**Minutes of the North Carolina Building Code Council**  
**December 14<sup>th</sup>, 2010**  
**Raleigh, NC**

**FIGURE R403.3 (1)  
CONCRETE AND MASONRY FOUNDATION DETAILS**

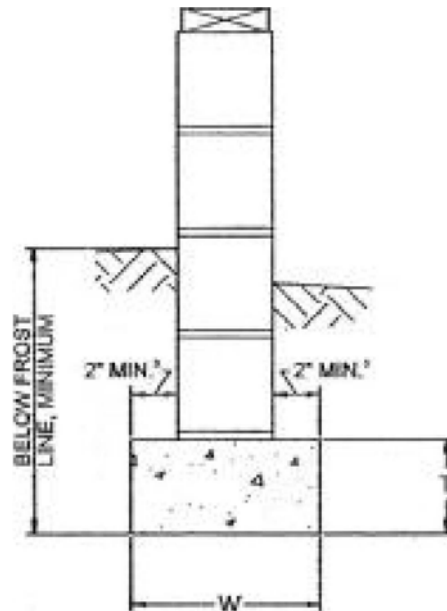
**Item B-20 Request by Robert Privott representing NC Home Builders Associations and Governor Beverly Perdue to amend the 2012 NC Residential Code, Table R403.3(1). The proposed amendment is as follows:**

1. Foundations shall extend not less than 12 inches below the natural grade or engineered fill finished grade and in no case less than the frost line depth.  
REMAINING NOTES TO REMAIN THE SAME
